SERVICE INSTRUCTION

DATE: July 2, 2003 Service Instruction No. 1485A
(Supersedes Service Instruction No. 1485)

SUBJECT: Exhaust Valve and Guide Identification Procedure

MODELS AFFECTED: All Lycoming reciprocating aircraft engines unless installed in a rotary-wing aircraft.

Figure 1.

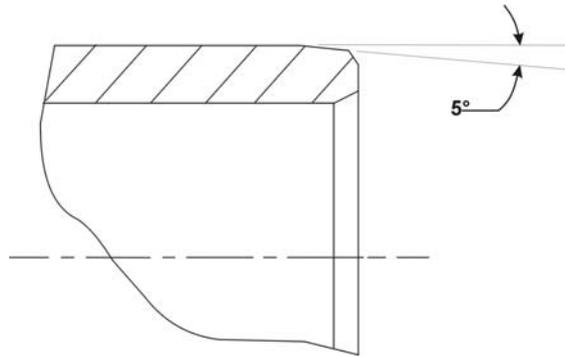
Cylinder assemblies which incorporated the improved "Hi-Chrome" exhaust valve guides when the engine was shipped from Lycoming are identifiable by the letter "C" stamped inside a circle on the boss for the drain back fitting. The individual guides made with the improved material can be identified by a 5° chamfer at the top of the guide (See Figure 1).
